Executive Director's Recommendation

Commission Meeting: November 7, 2019

PROJECT Second Division Memorial Modification President's Park Constitution Avenue, NW & 17th Street, NW Washington, DC	NCPC FILE NUMBER 8120 NCPC MAP FILE NUMBER 1.31(73.10)45017
SUBMITTED BY United States Department of the Interior National Park Service	APPLICANT'S REQUEST Approval of comments on concept plans
REVIEW AUTHORITY Commemorative Works Act per 40 U.S.C. § 8905	PROPOSED ACTION Approve comments on concept plans ACTION ITEM TYPE Staff Presentation

Option D – Preferred

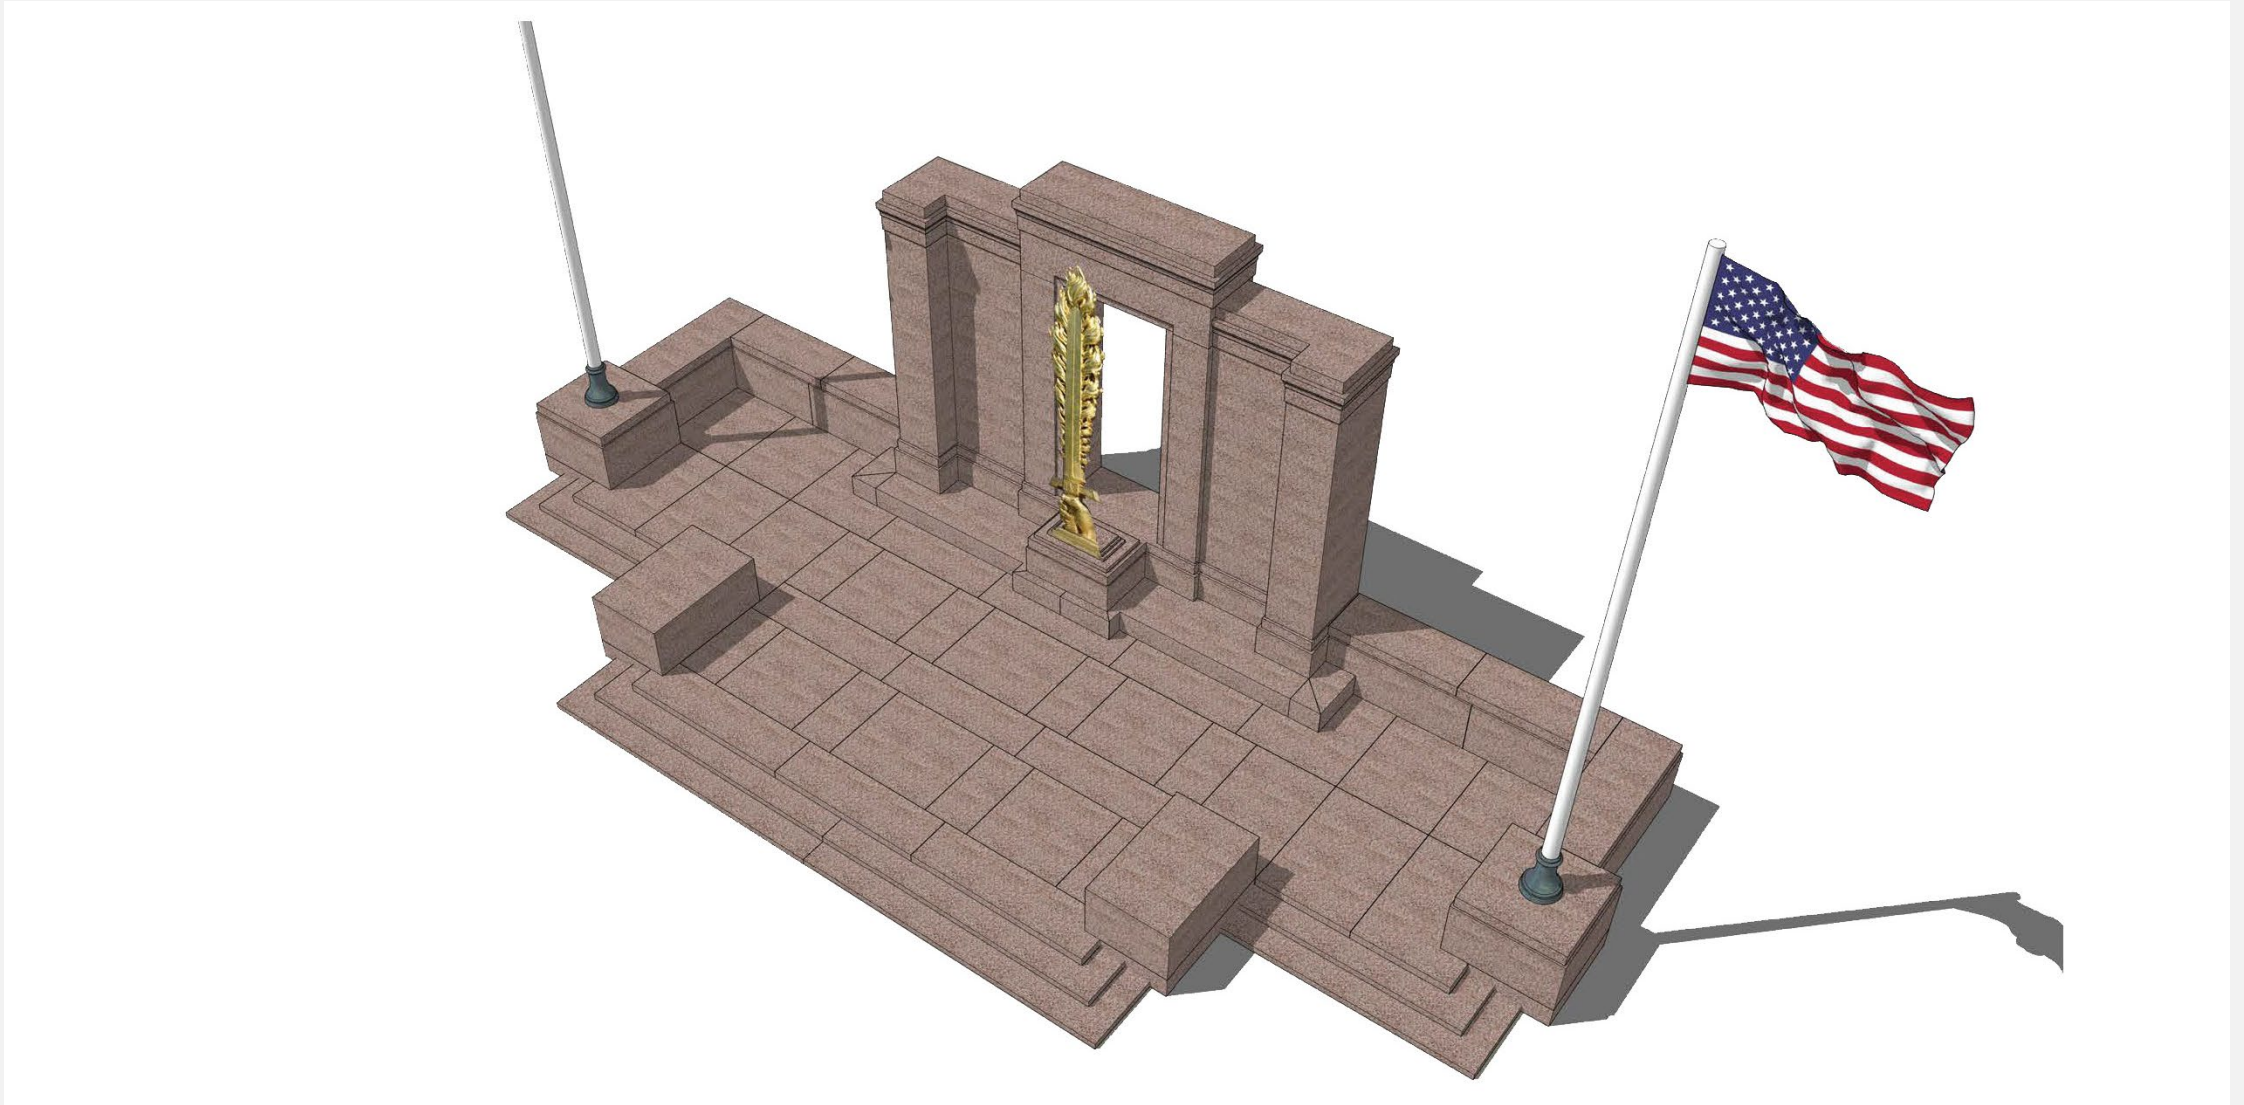
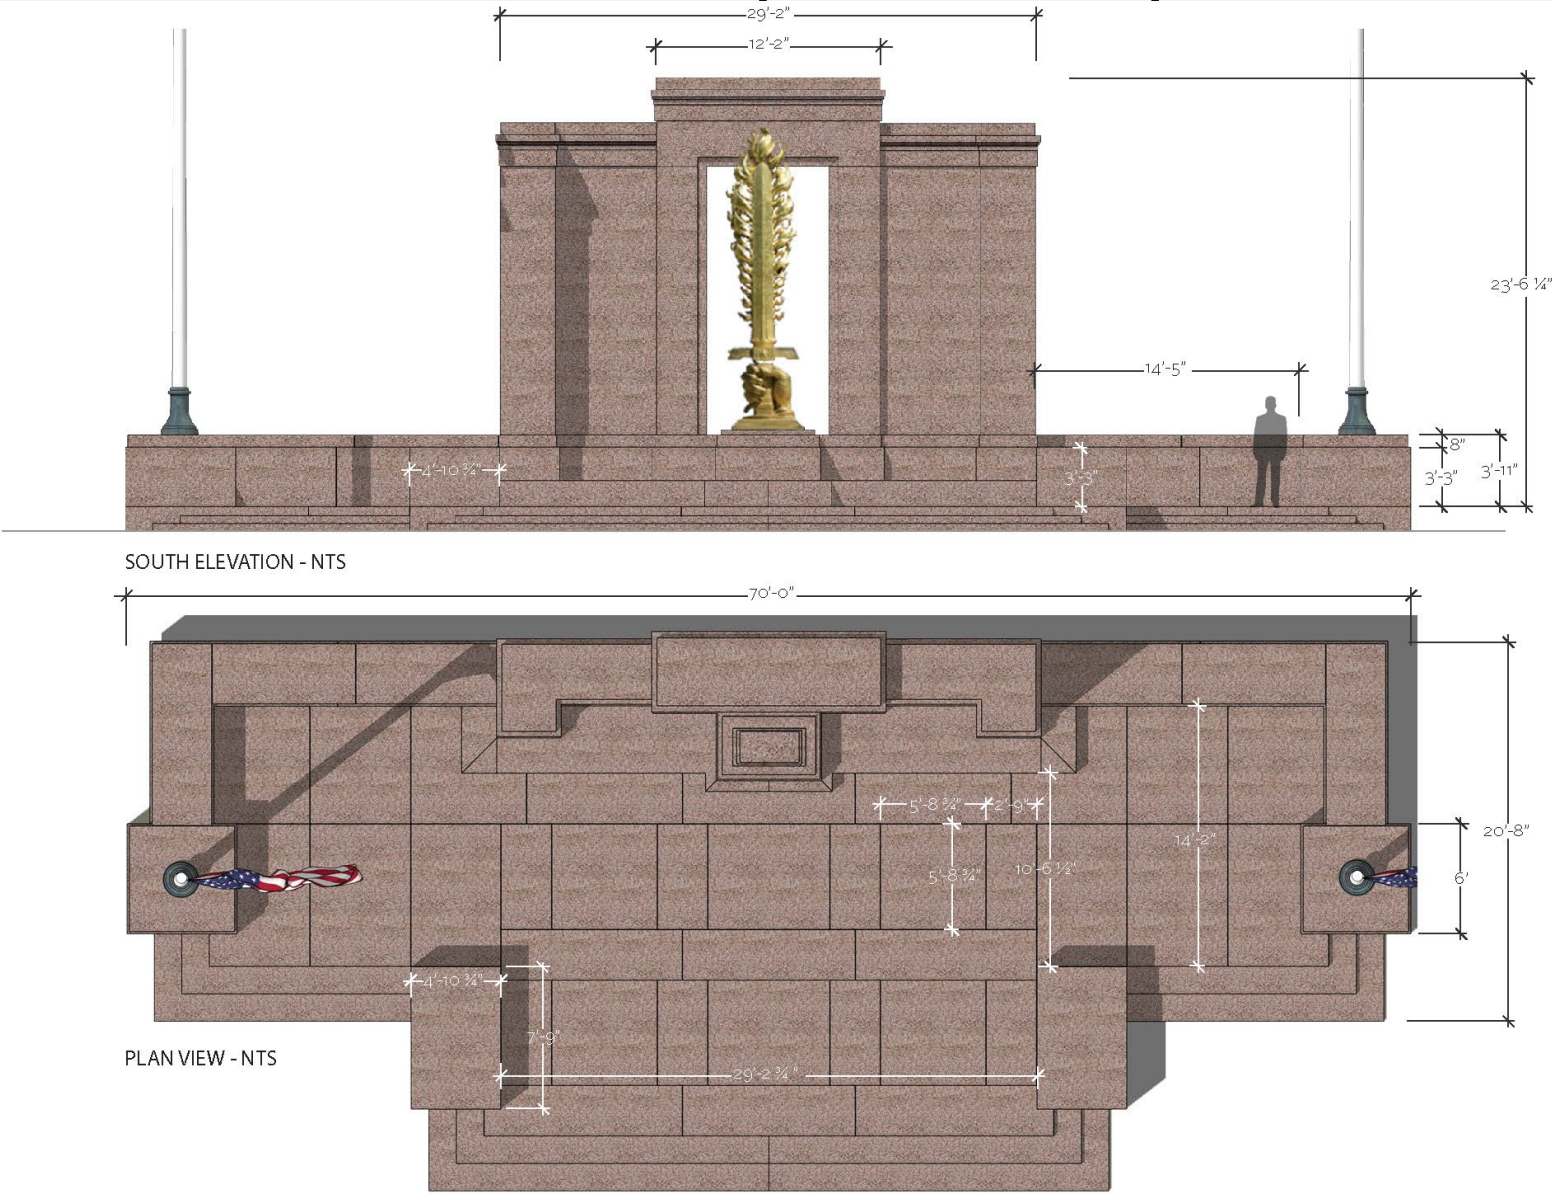
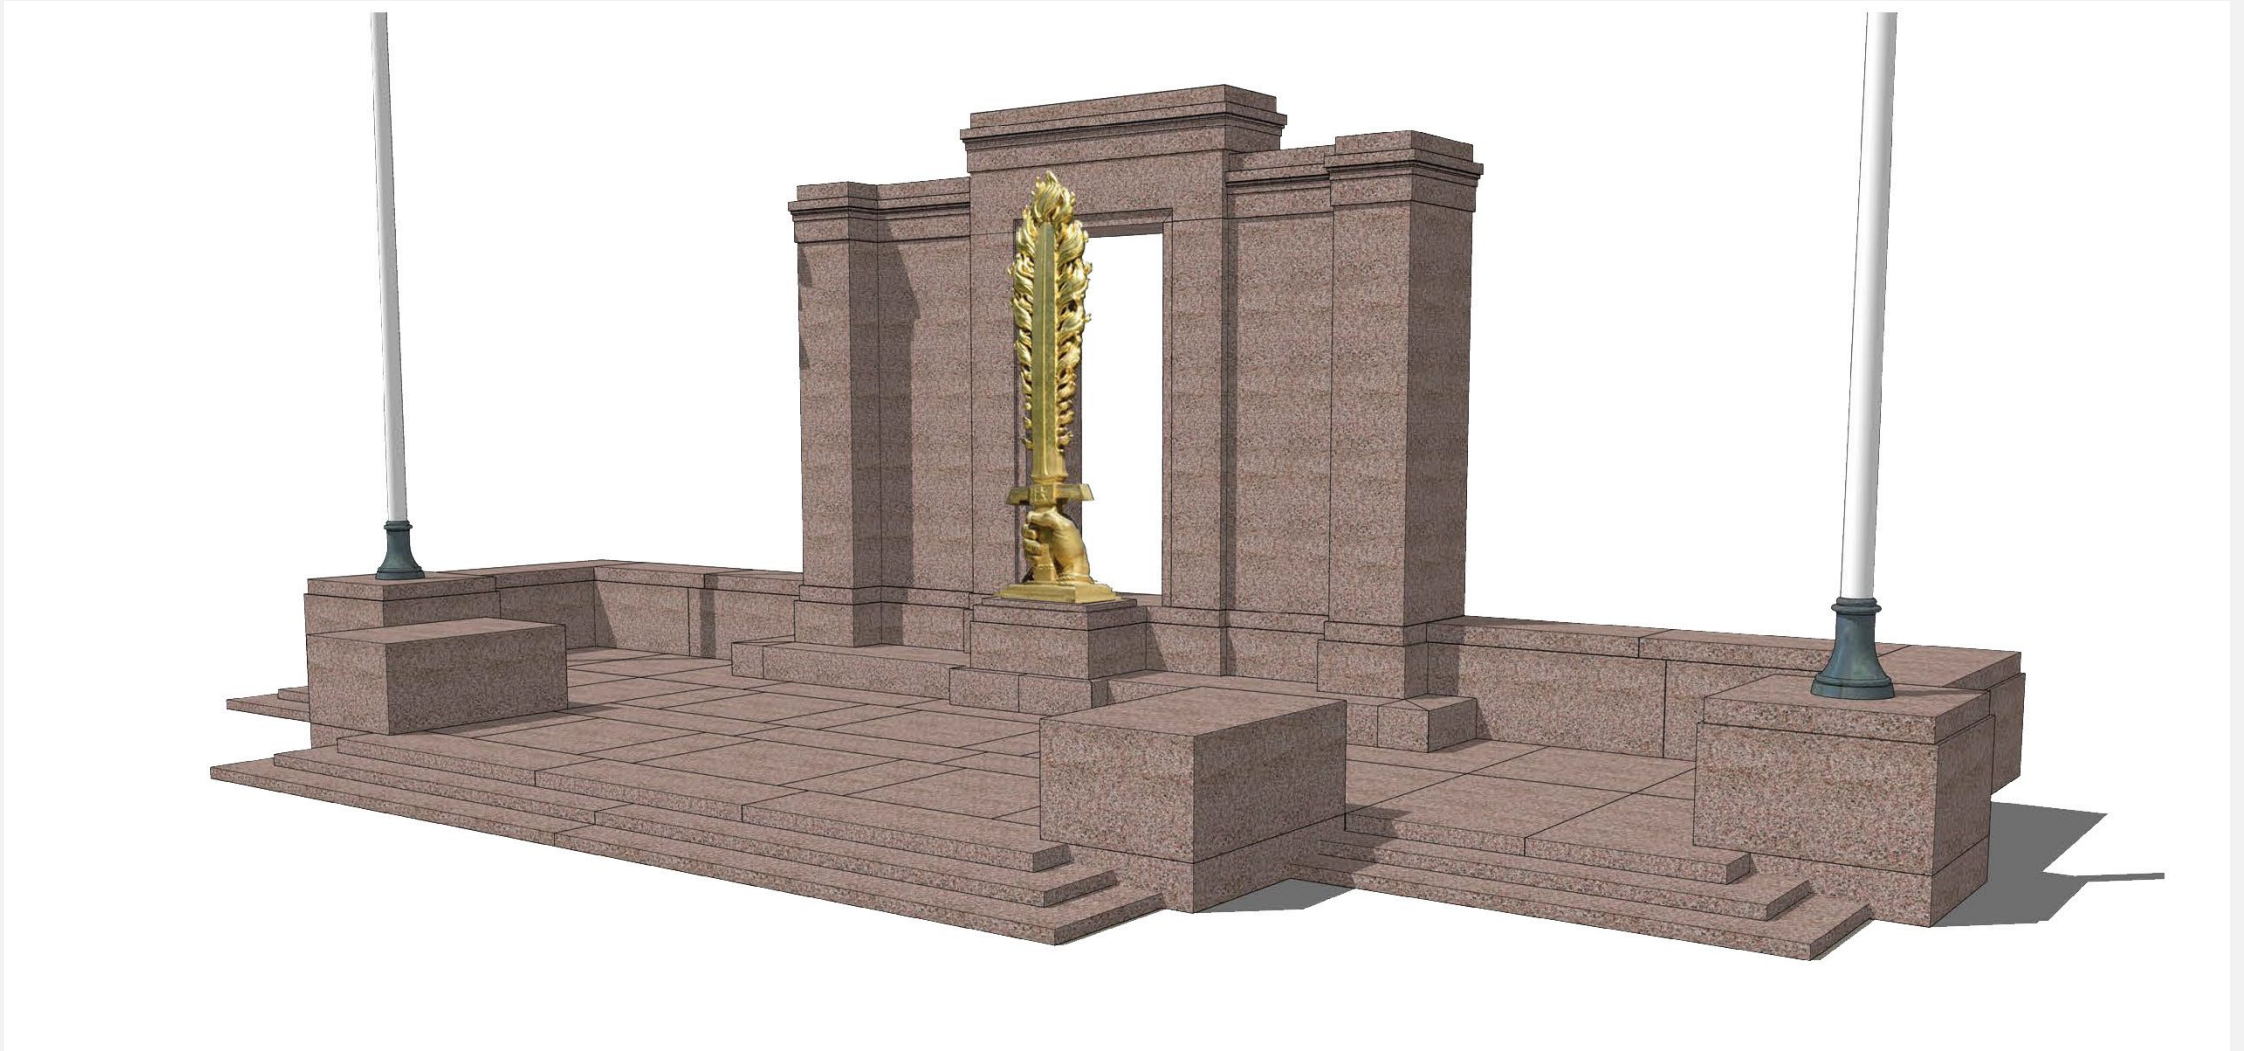
Supports Option D as the preferred approach, even though it alters the memorial design, because the addition is consistent with the previous approaches to the memorial’s expansion; does not create “pinch points” for pedestrian movement; reinforces the front of the memorial; and creates a gathering area within the memorial for visitors and small ceremonies.

Option D does expand the footprint of the memorial. However, the approach is additive instead of altering the existing memorial fabric. This approach is also consistent with how the memorial has been expanded in the past. Option D allows for a gathering space in the memorial, and also helps reinforce the frontality of the original design. Most importantly, Option D does not create the same pedestrian "pinch-points" described in Option A, B, and C. As such, staff recommends the **Commission supports Option D as the preferred approach, even though it alters the memorial design, because the addition is consistent with the previous approaches to the memorial's expansion; does not create "pinch points" for pedestrian movement; reinforces the frontality of the memorial; and creates a gathering area within the memorial for visitors and small ceremonies.**

The Commission members found that Option D-1—which extends the memorial's raised platform southward to accommodate two new stone plinths, reproduces the existing central stepped approach, and provides barrier-free access to the platform—would appropriately integrate the new addition within the historic memorial and its 1960s expansion. For the refinement of the design, they advised pursuing a subtle differentiation of the new paving from the existing, an approach which they characterized as successful in the earlier extension. They recommended further study of the configuration and grading of the proposed curvilinear walkway from Constitution Avenue, suggesting that the widely arcing path could be slightly asymmetrical in response to the context and character of the Ellipse; they also suggested elimination of the existing flower beds as the landscape design is developed.

OPTION D1

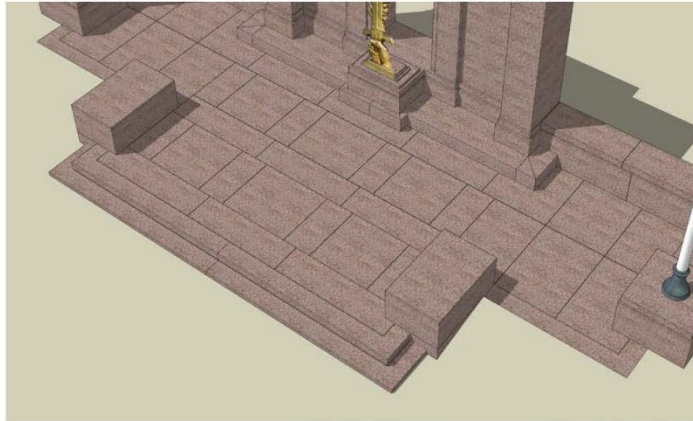
Supports re-grading the site to allow for direct, level access to the memorial from the side panels, while retaining the more ceremonial steps at the center of the memorial platform (Option D1).

The memorial includes a series of low steps and sits in the middle of a lawn panel. As such, it is not directly accessible by those of all abilities, particularly those in wheelchairs. Three options to provide access to the memorial platform were explored, to include re-grading the area in front of the memorial to eliminate the need for steps. The re-grading could eliminate all steps (Option D3), just the middle steps (Option D2), or just the side steps (Option D1). The central steps are important both architecturally and ceremonially. As such, retaining these central steps while allowing at-grade access from the site side panels appears to be the best solution. As such, staff recommends the **Commission supports re-grading the site to allow for direct, level access to the memorial from the side panels, while retaining the more ceremonial steps at the center of the memorial platform (Option D1).**

Memorial Access – Linear Approach

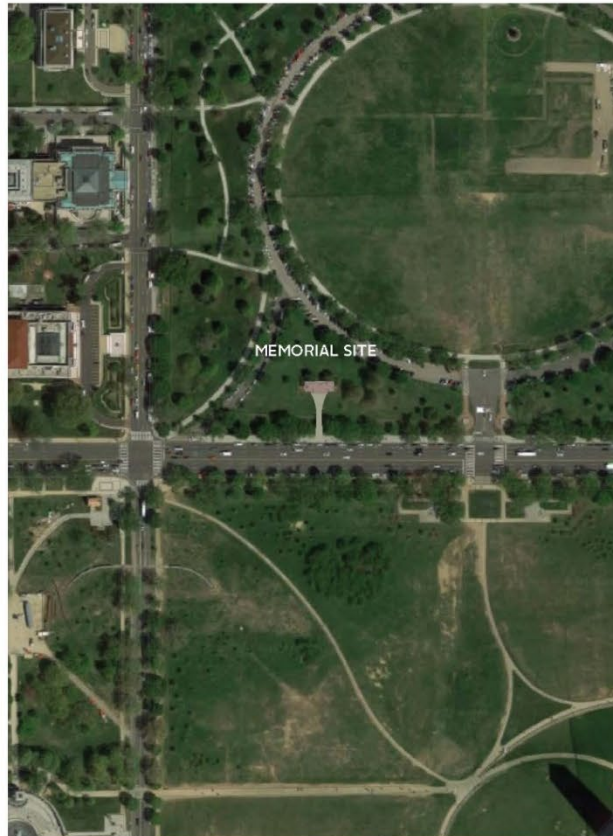
Finds the open grassy field is a character-defining feature that is important to the setting of the memorial, and therefore a linear path is not appropriate as it would alter this setting.

pathway options that would allow for an accessible route to the memorial. These options consider the desire lines of pedestrian as well as the setting of the memorial, and how it is viewed. The first option is a single, direct linear connection from Constitution Avenue to the memorial. In this option, the setting of the memorial would change as viewed from the south. The open grassy field is a character-defining feature that is important to the setting of the memorial. As such, a linear path is not appropriate as it would alter this setting.

Memorial Access – Curvilinear Approach

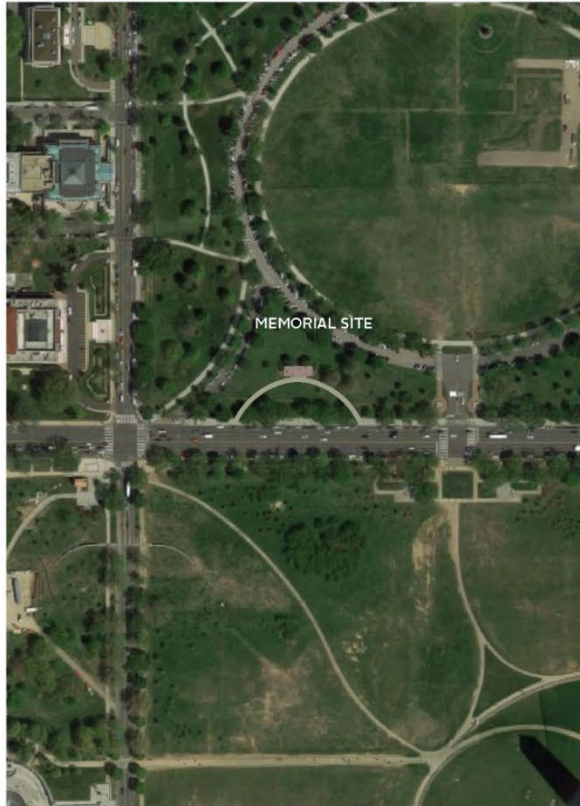
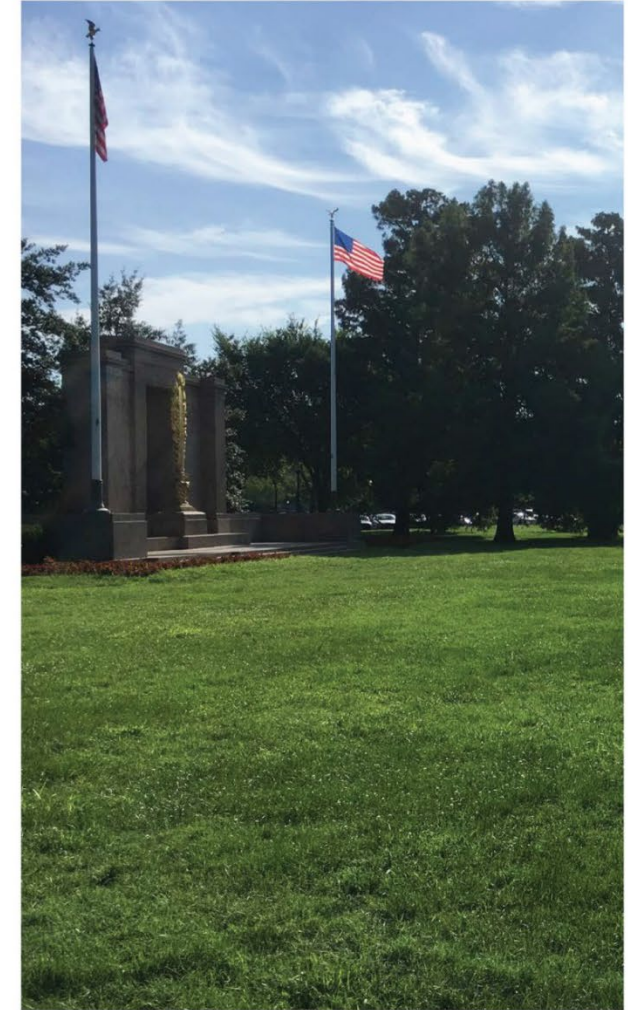
Notes the curvilinear path has a form similar to many of the secondary paths within President’s Park South, and this alignment would preserve the setting of the memorial within the lawn, but the wide arc of the path may lead to pedestrians cutting across the lawn.

The second option is a curved walkway that links the memorial with Constitution Avenue on both ends of the path. In this case, the curvilinear path has a form similar to many of the secondary paths within President's Park South, and this alignment would preserve the setting of the memorial within the lawn. However, the wide arc of the path may lead to pedestrians cutting across the grass to find a more direct route to the memorial. Therefore, staff suggest the **Commission recommend evaluating a pathway option that accesses the memorial from the side panels, but where at least one leg of the pathway is more directly connected to Constitution Avenue to preclude pedestrians from cutting across the lawn.**

Recommends evaluating a pathway option that accesses the memorial from the side panels, but where at least one leg of the pathway is more directly connected to Constitution Avenue to preclude pedestrians from cutting across the lawn.
